To: All Plan Holders of Record

Re: *Addendum No. 1*
Lake County Executive Airport Terminal
Lake Development Authority

Date: June 17, 2024

SCALE:	1/4" = 1'-0"
CONTRACT NO:	24160
SHEET	M1.01

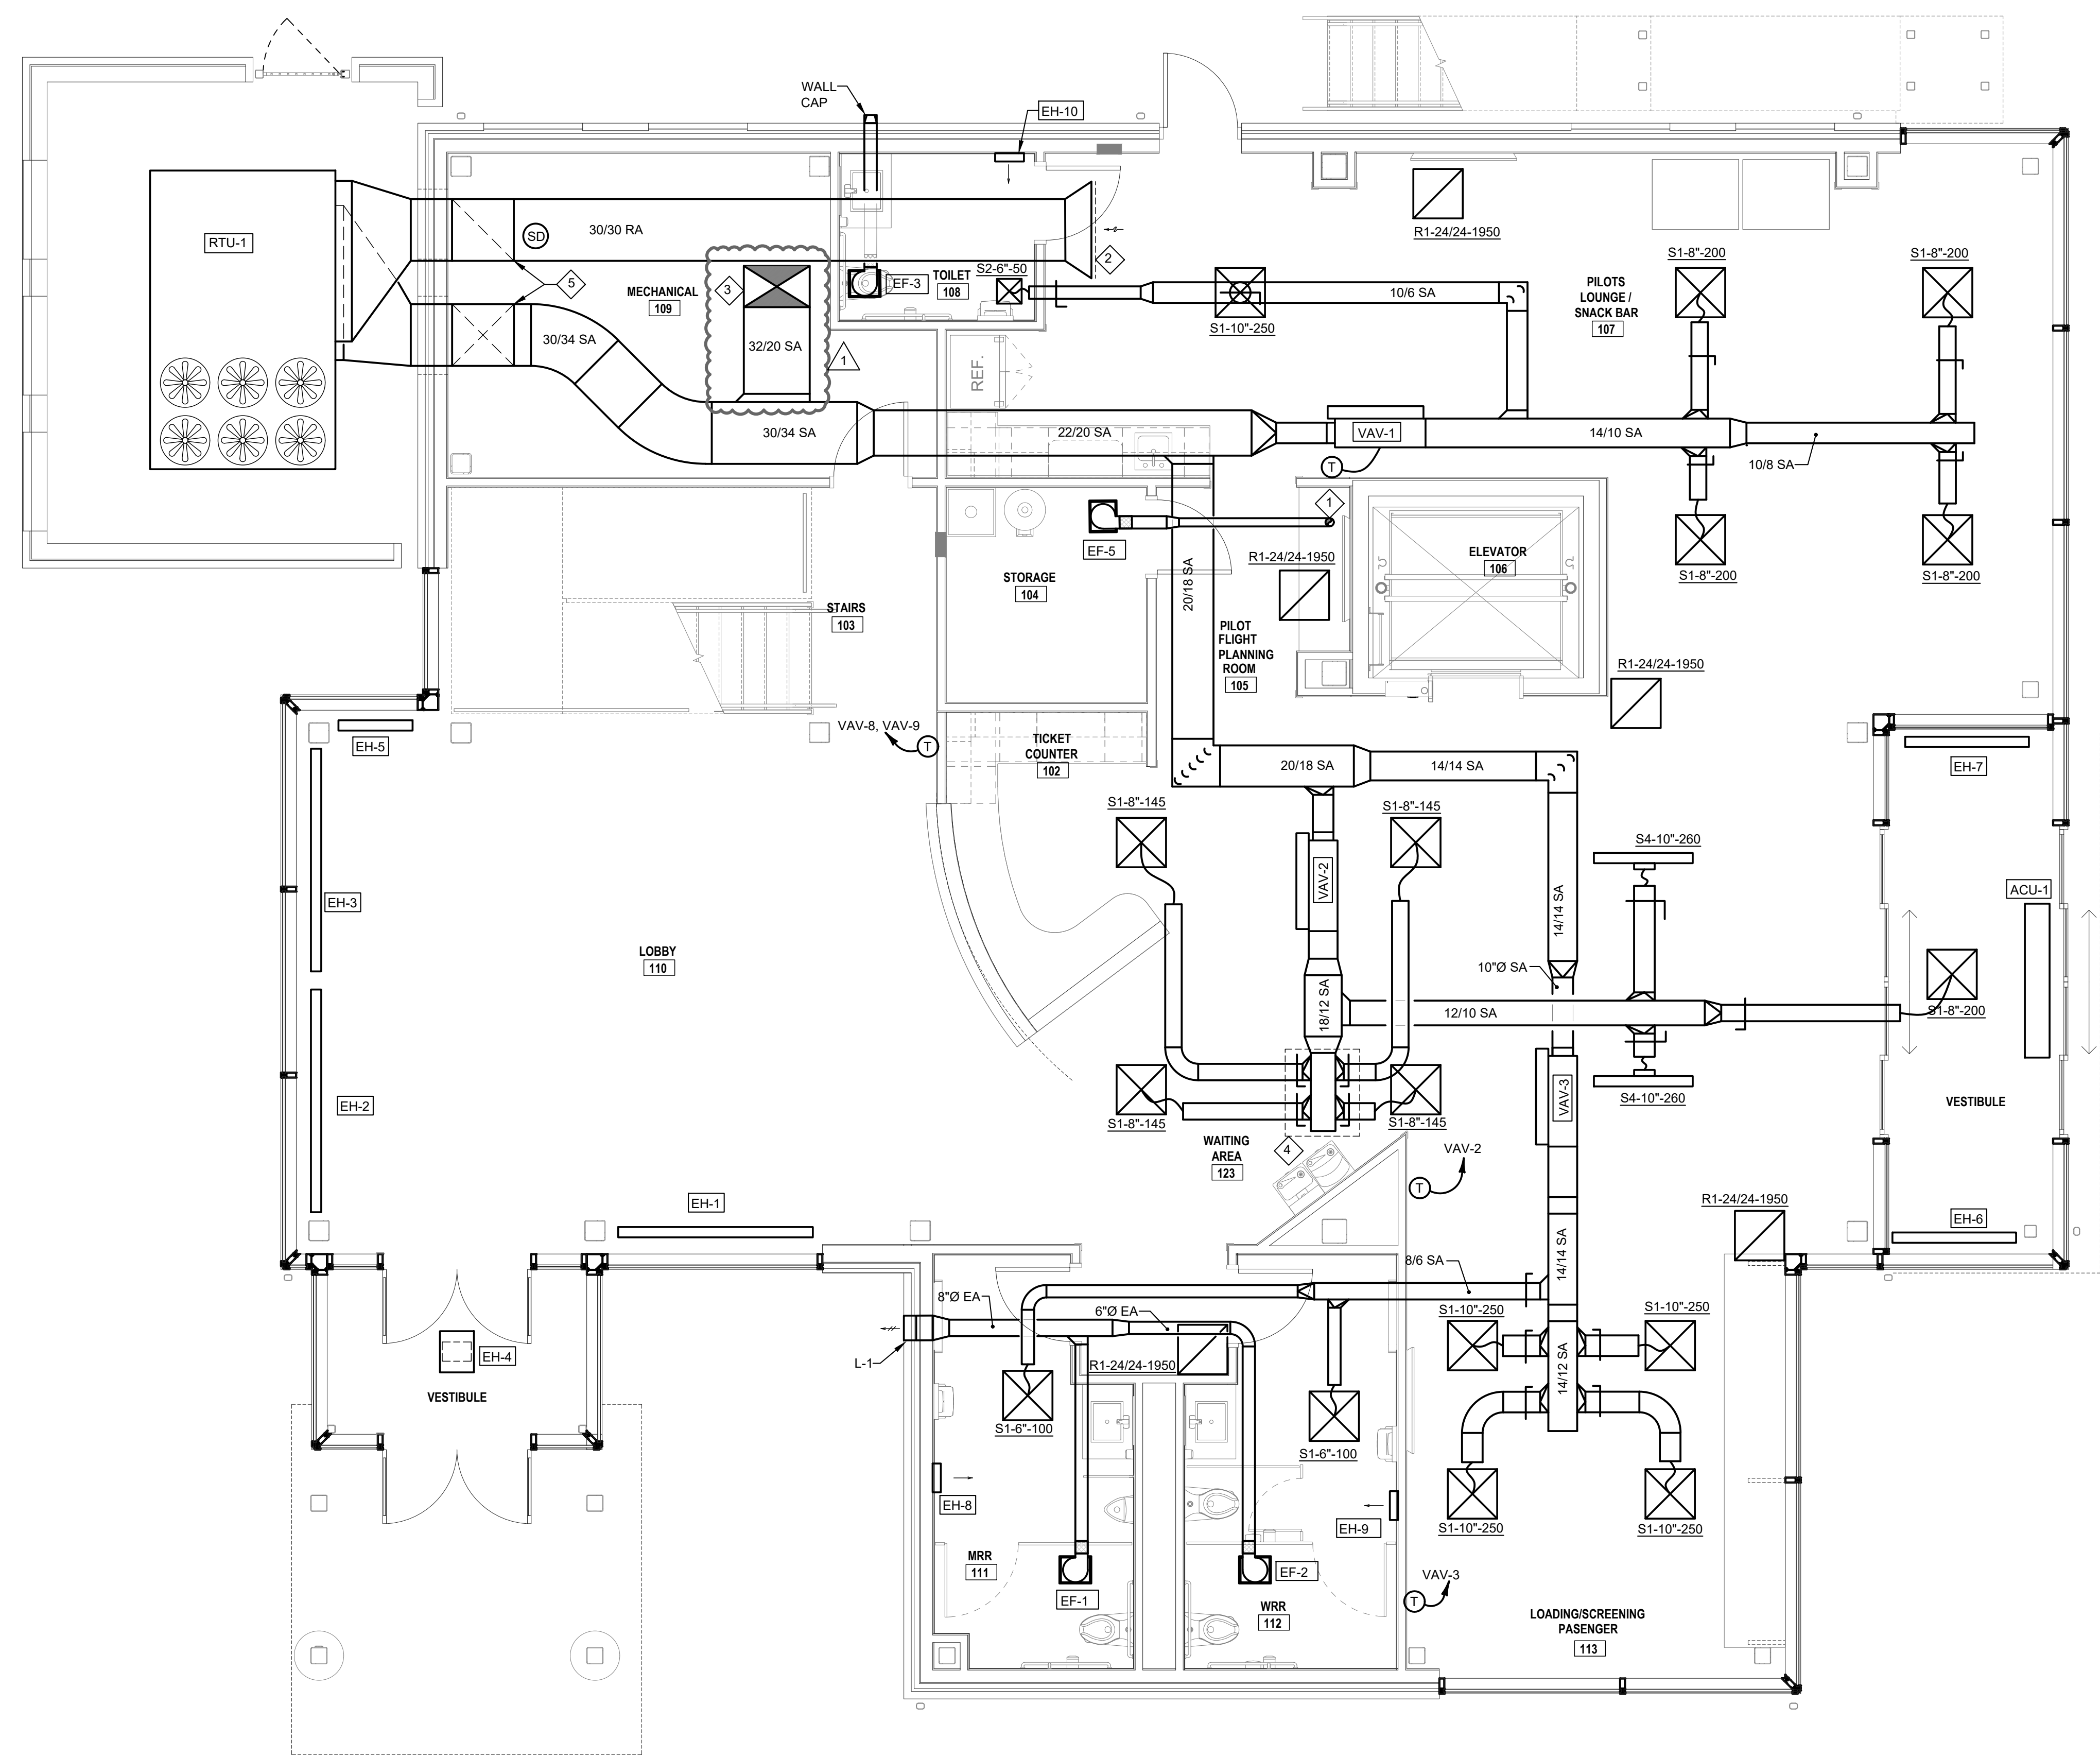
20. M1.01 shows a duct up to second floor at mechanical room 109. S1.2 floor framing plan does not show opening in second floor for this. Can this be added along with framing details for opening.

Response: See typical opening framing detail on S3-1. Coordinate exact location with Mechanical Contractor.

SCALE:	1/4" = 1'-0"
CONTRACT NO:	24160
SHEET	E1.06

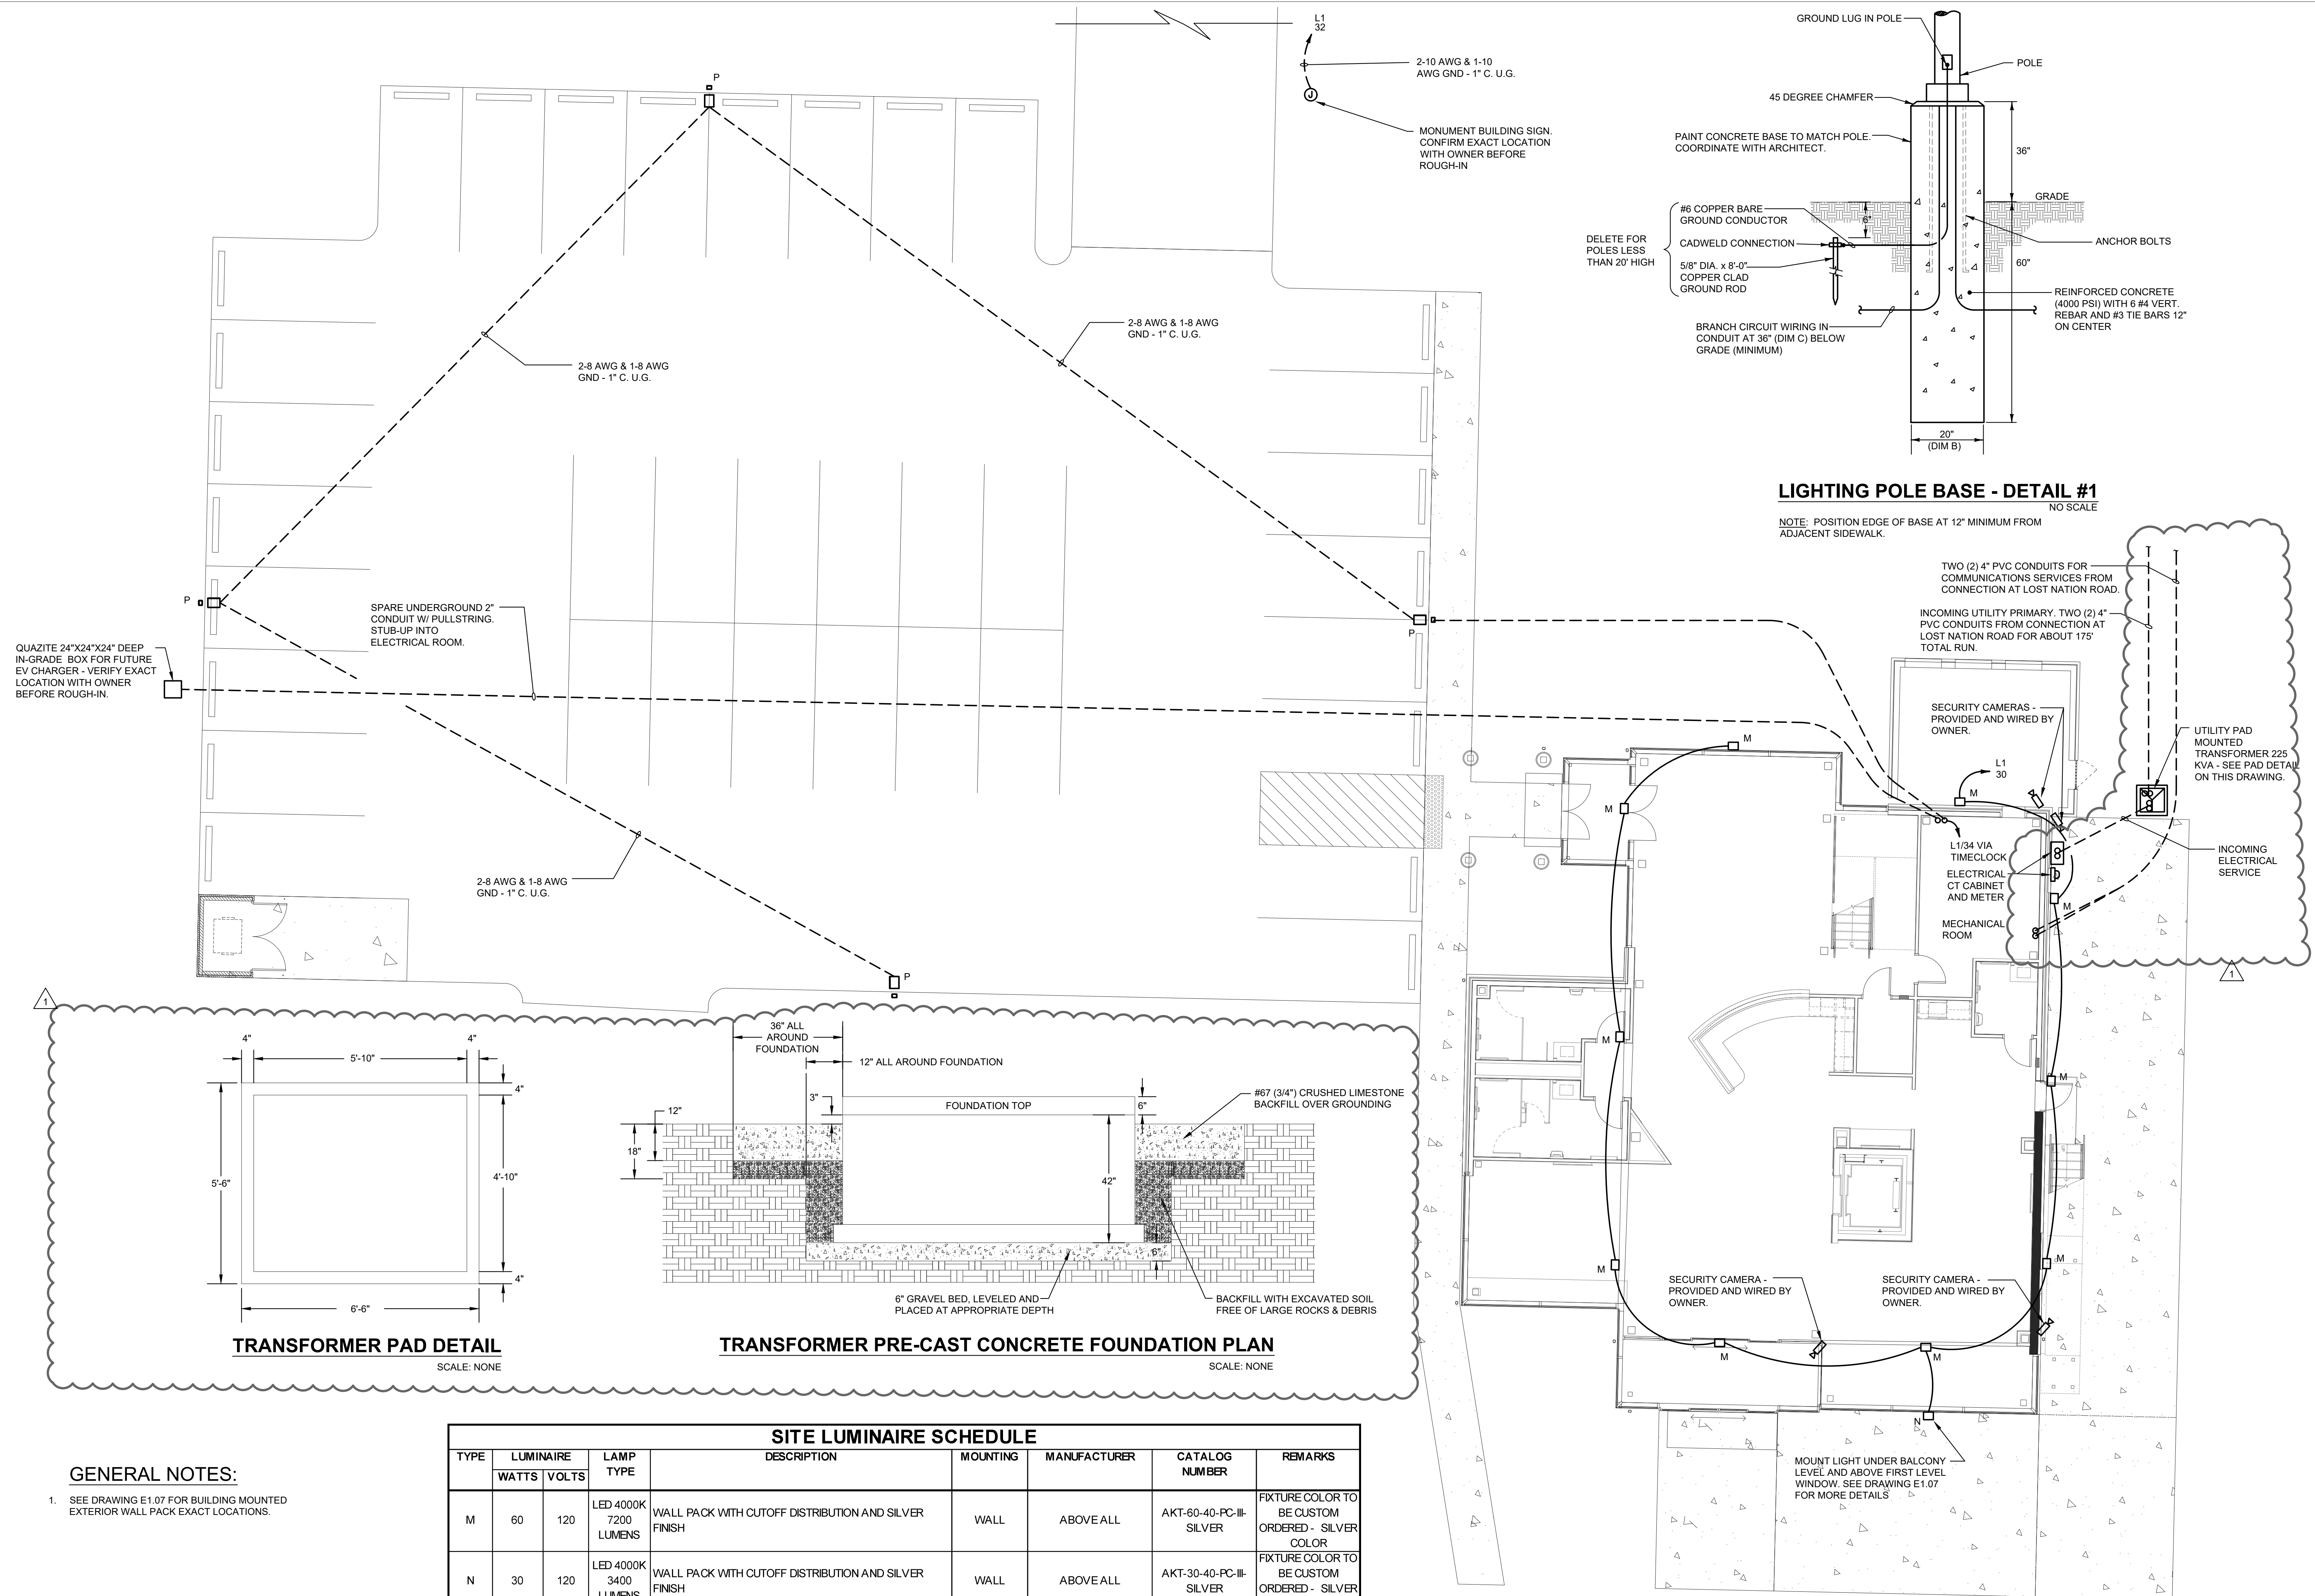
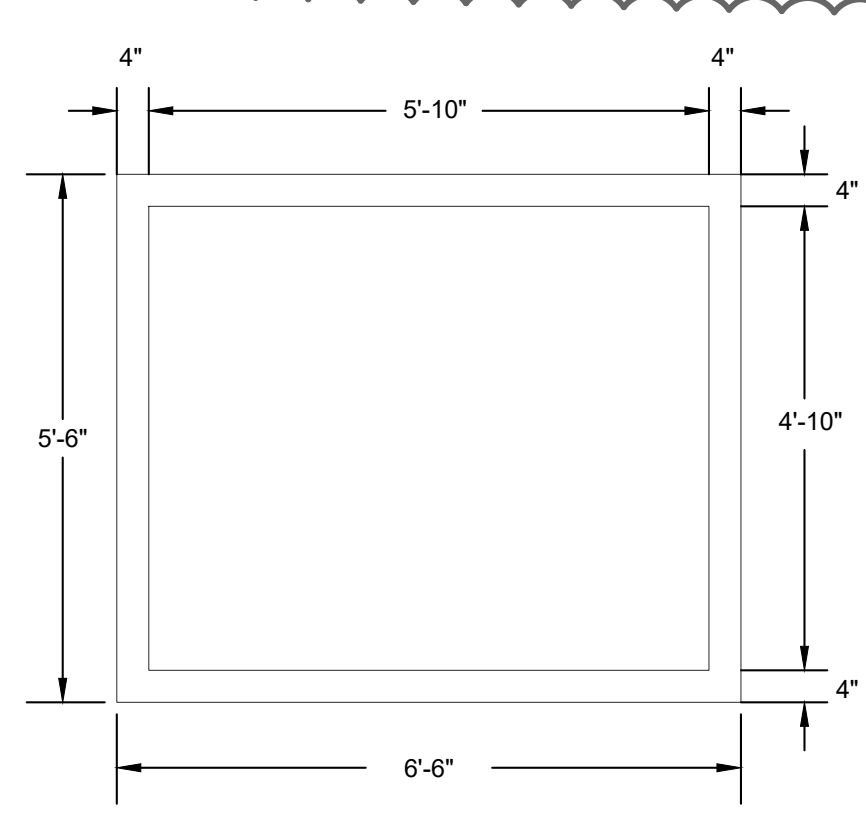
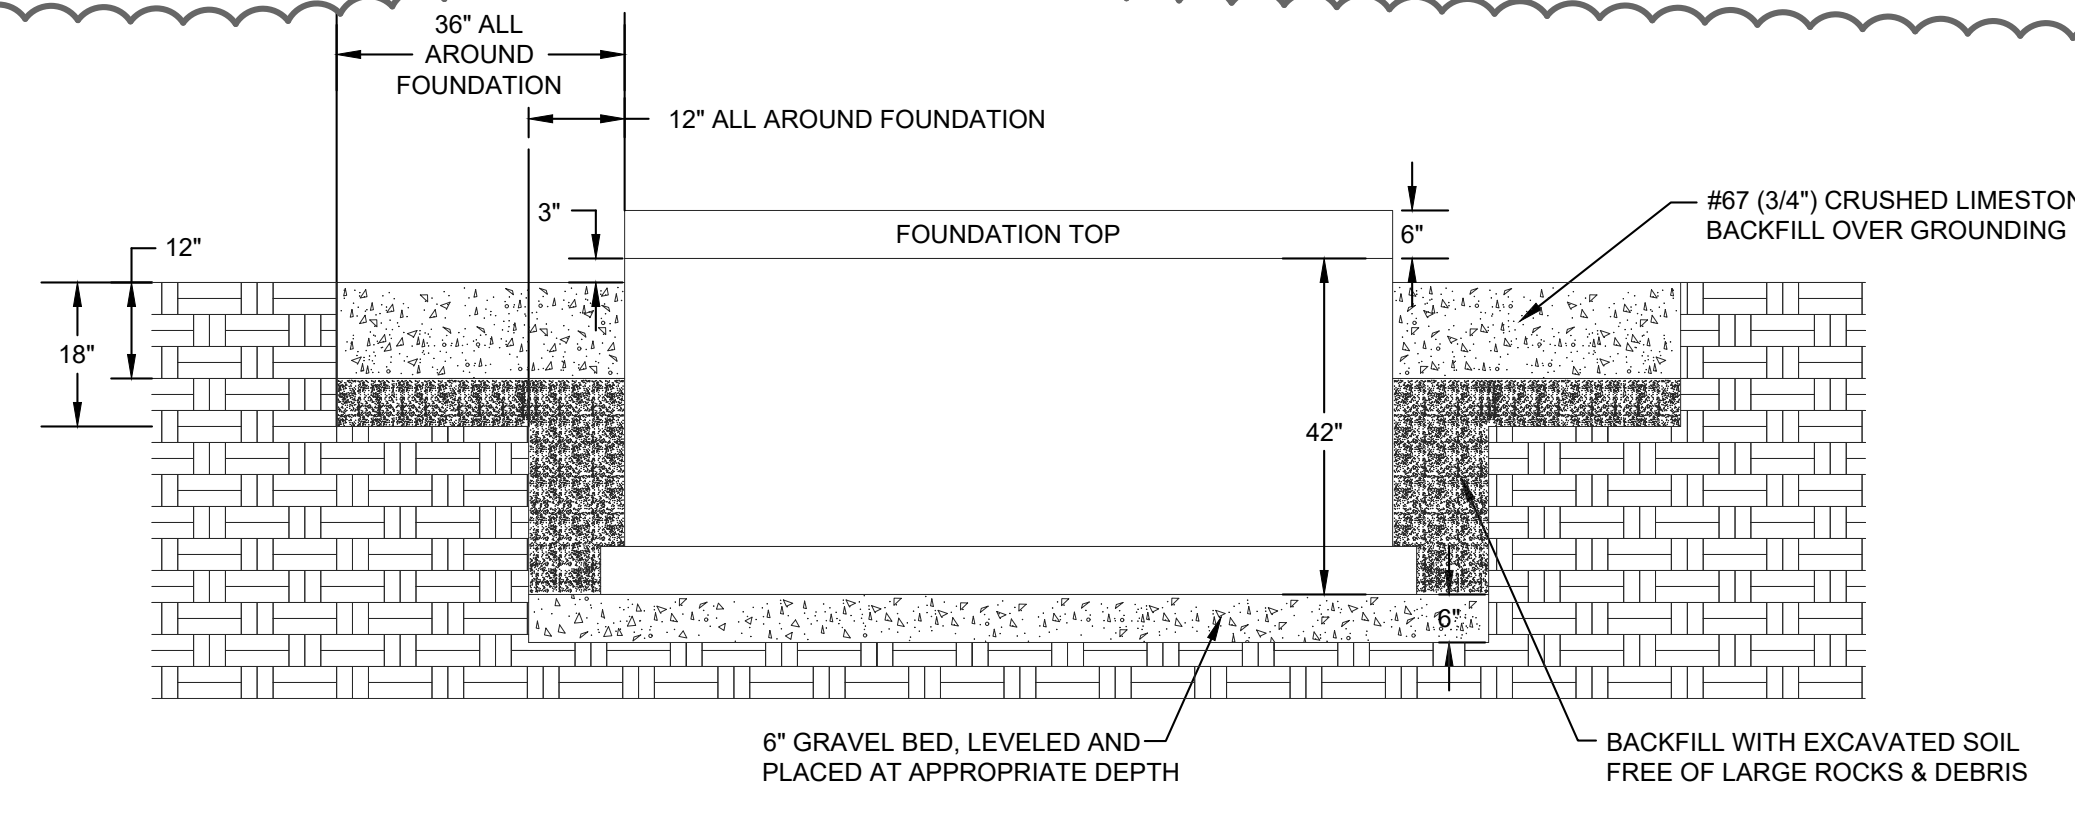
8. The electrical site drawing E1.06 does not provide a location from where the incoming utility service is coming from, and what the total distance on the run is. The site utility drawing C1.04 does show the rough location of the existing utility underground electric, but it does not show where the proposed location for the utility transformer will be located.

18. Sheets E1.06 and C1.04 do not appear to reflect the full primary and secondary power scope of work nor is the utility transformer location provided. Please coordinate to reflect the full primary and secondary power responsibilities as well as provide the utility transformer location.

Response: See revised drawing E1.06.

Response: See revised drawing E1.06.
